Control Number: 123410

Applicant: C. PAD TECHNOLOGIES, Inc.

UNITED STATES  
NUCLEAR REGULATORY COMMISSION

Docket No. 030-34197  
Control No. 123410

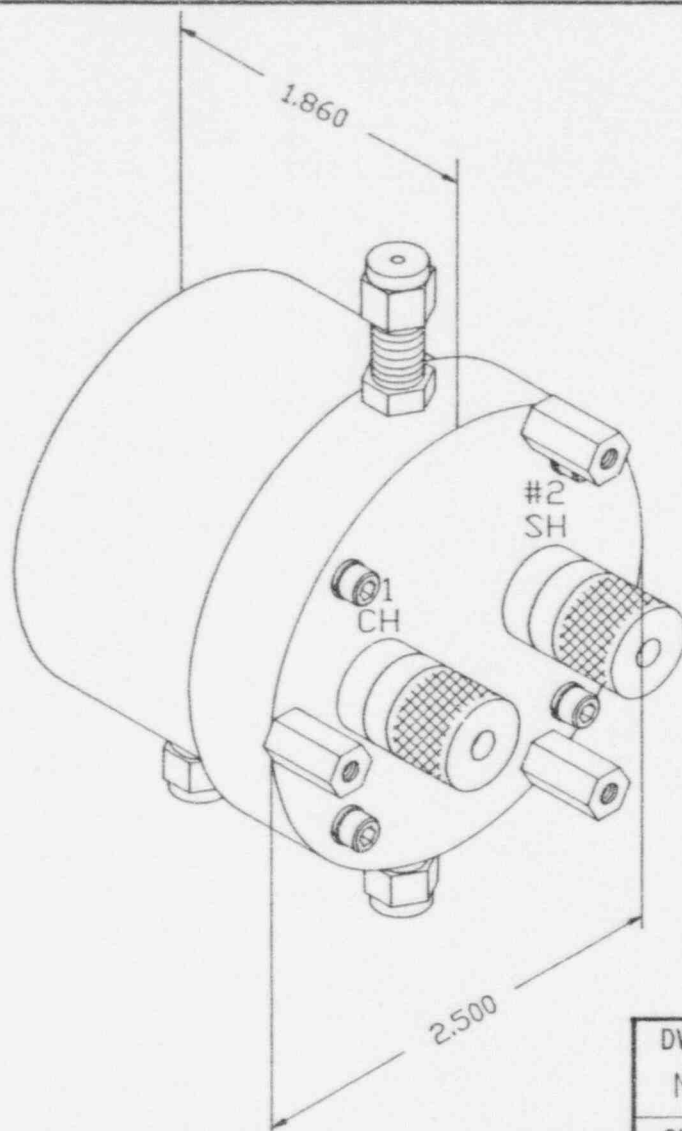
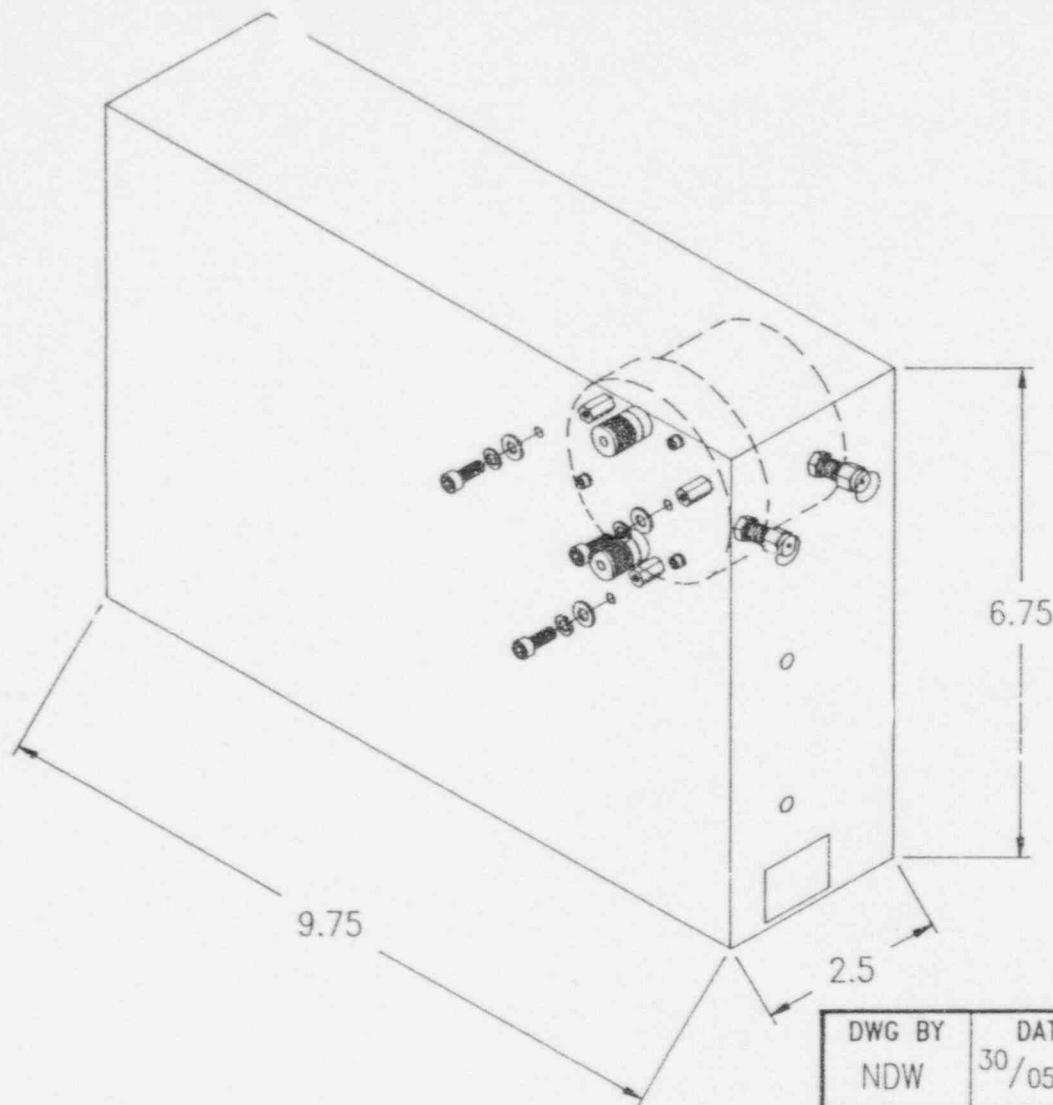
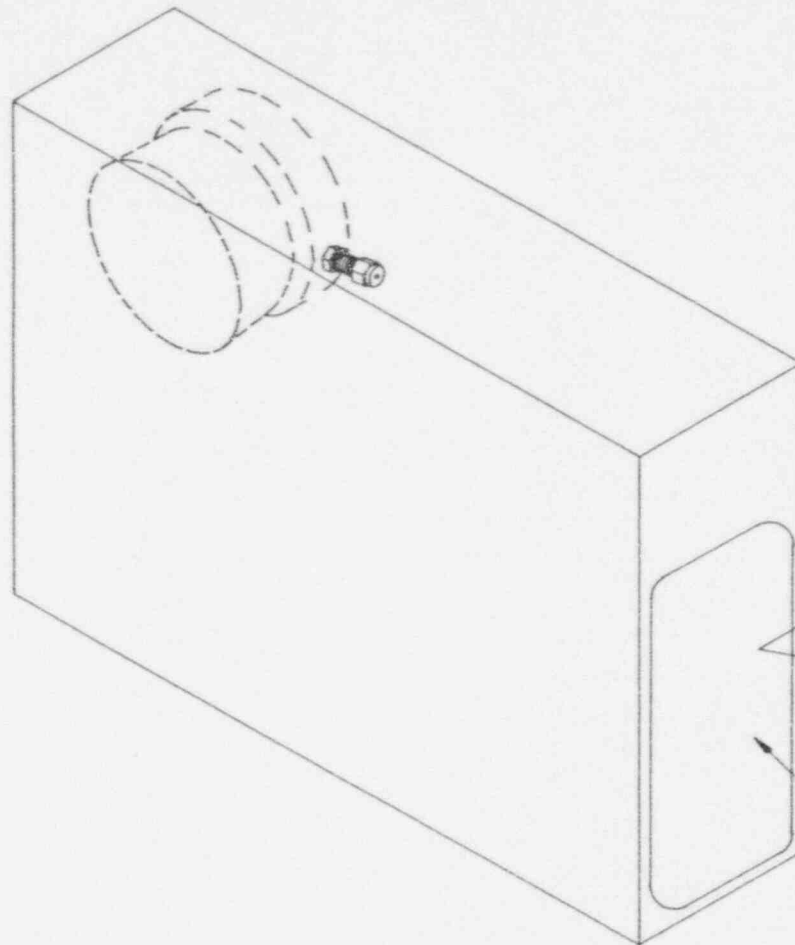
It was noted in the engineering drawings submitted that a statement was made on each that it is considered to be the property of CPAD Technologies Inc. The NRC can handle information submitted by licensees on a company proprietary manner (i.e., not to be disclosed to the public) when the materials are submitted in accordance with 10 CFR 2.790(b). In addition to the markings on the material to be considered proprietary, an affidavit is required to be submitted requesting that the materials be considered proprietary. Once this has been received, the NRC will consider the request on its merits.
